Subject: Energy Connect (NSW – Western Section) - SSI 10040 - Response to Submissions

ATTACHMENT A – BCD comments on Energy Connect (NSW – Western Section) - SSD 10040 - Response to Submissions

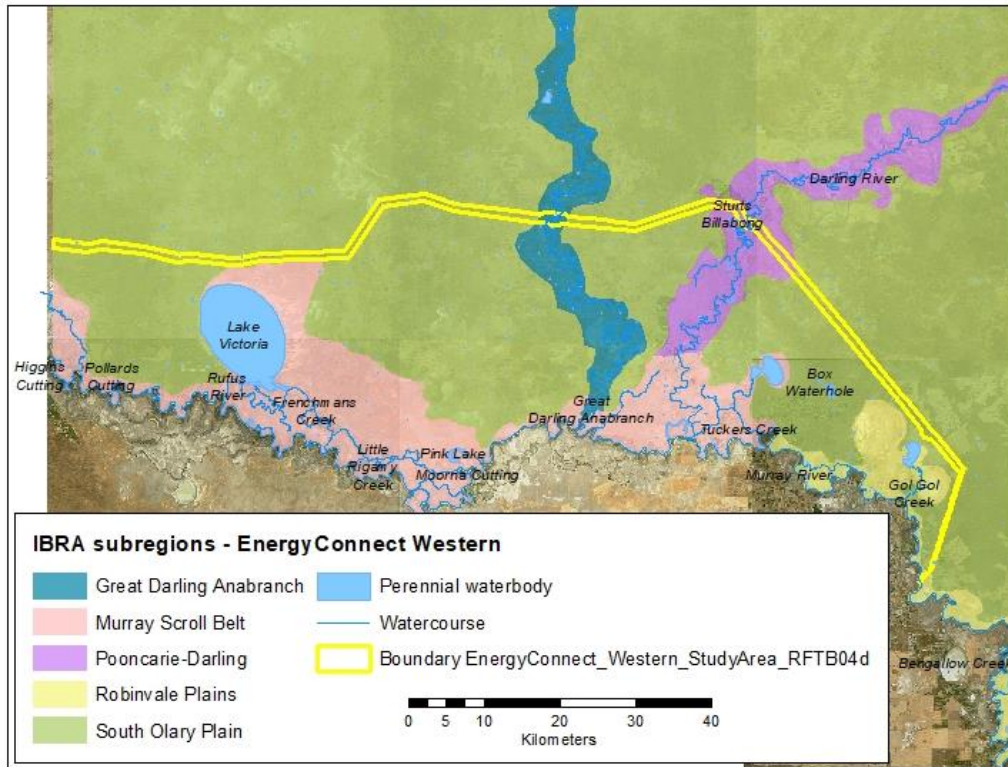
BCD Issue 8	The BAM should document all the vegetation zones in the four (now five) assessed IBRA subregions.
	<p>1. The BDAR needs to identify Vegetation Zones assessed on the development site, enter them into the BAM calculator, demonstrate adequate sampling, and clearly show the results through tables and maps in the BDAR.</p> <ul style="list-style-type: none"> • Section 3.6.5 states that Tables 3.9 to 3.13 provide the number of VI plots required for each native vegetation zone in the five IBRA subregions, and the plots that were sampled in each zone. • However, the tables list the PCTs in each IBRA subregion, not vegetation zones. They do not refer to the Vegetation Zone identifiers in BAM-C. Without those identifiers, there is no clear and unambiguous link between the information in Section 3.6.5 and the calculator. The spatial datasets must also include the BAM-C Vegetation Zone identifiers. • To demonstrate adequate survey effort, the BDAR is required to provide the number of plots in each vegetation zone. It may be appropriate to use VI plots from one zone to generate a VI score in another zone, however the BDAR should clearly identify where this has occurred.

2. A fifth IBRA sub-region has been added to the assessment.

For clarity, BDAR Table 4.1 (page 52) should include the area of each subregion (and % total area) within the development footprint. Consistent with BAM minimum requirements (requirements (Table 25 Appendix 10, BAM 2017) a map of the subregions would also be informative, for example:

8.2. Summarise area of each subregion in Table 4.1 and include a simple subregion map.
